GOVERNMENT OF THE DISTRICT OF COLUMBIA
DEPARTMENT OF TRANSPORTATION

MEMORANDUM

SUBJECT: Zoning Commission Case No. 15-07 – 315 H Street NE

Figure 1. Site Plan (Source: Applicant)

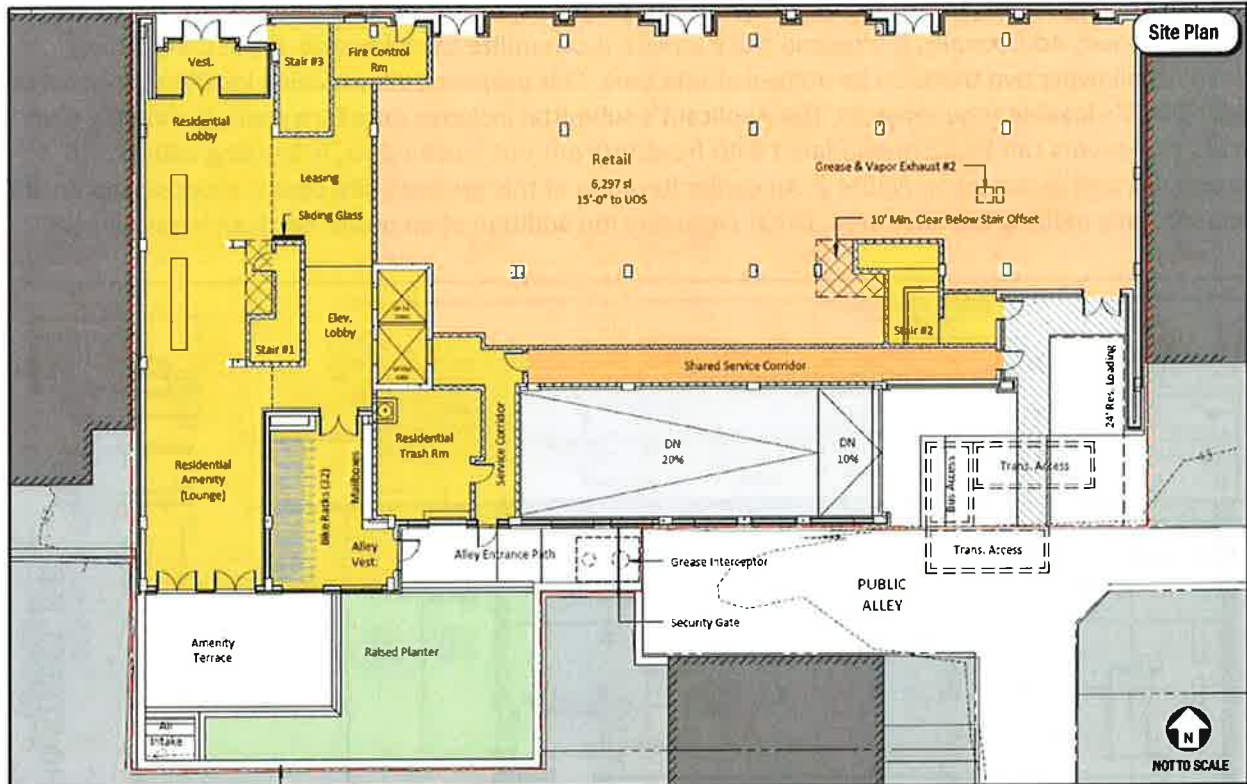
This Site is located along the south side of H Street NE between the intersections of 3rd Street and 4th Street, with an alley behind the eastern portion of the proposed development where the Applicant proposes vehicle and loading access. The alley passes through from 4th Street before heading south (ultimately to 3rd Street) behind the proposed development, and is relatively narrow in some areas. This would serve the building from the rear, allowing access to the 30 vehicular parking spaces, along with a 24' loading berth. Additional loading for retail uses would occur in the existing on-street loading zone on 4th Street. The proposed site access is consistent with DDOT's approach to site access, which seeks alley access and that the number of curb cuts be minimized.

Primary pedestrian access points are located along H Street for both retail and for residential. Bicyclists will access the 50 bicycle parking spaces provided within the building either via the lobby or the rear entrance.

Figure 2. Truck Entry (Source: Applicant)

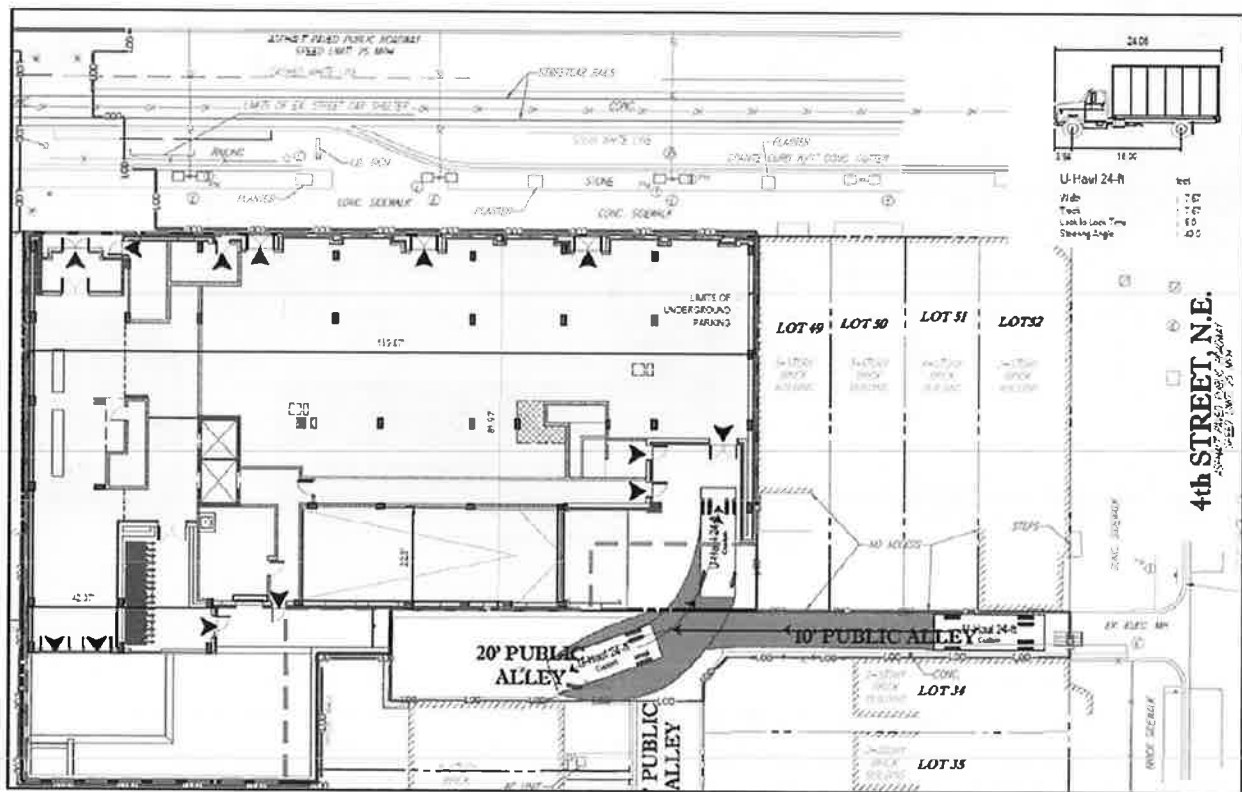
The Applicant is seeking relief from the 30-foot and 55-foot loading dock requirements (for retail and residential, respectively). A 24-foot loading berth is proposed for trucks serving the residences at the building's rear. Additionally, if a second truck arrives, it can utilize the alley stub at the rear of the building, allowing two trucks to be utilized at one time. This proposed alley loading location is consistent with DDOT's loading requirements. The Applicant's submittal includes AutoTurn analysis showing that truck maneuvers can be accommodated with front-in/front-out movements, in keeping with DDOT standards, and as shown on *Figure 2*. An earlier iteration of this project's site design proposed no onsite loading, only utilizing the alley area. DDOT considers the addition of an onsite berth an improvement.

While H Street has a parking lane, streetcar service at this location does not allow for loading activities to occur as the parking lane is too narrow to allow truck parking without interference with streetcar operations. Trucks that are too large to utilize the alley or rear on-site loading facility or serving the retail component will also need to serve the project. An existing loading zone is located on 4th Street, which can be utilized for this purpose, but will require trucks to move through the neighborhood to access the loading zone. And retail deliveries will require goods movement along the sidewalks between

the loading zone and the retail entrances. These loading operations are not optimal, but are acceptable considering the constraints caused by the streetcar and narrow alley area.

With the onsite loading berth accommodation, and given the proposed land uses, the loading relief is appropriate and unlikely to significantly negatively impact the District's transportation network.
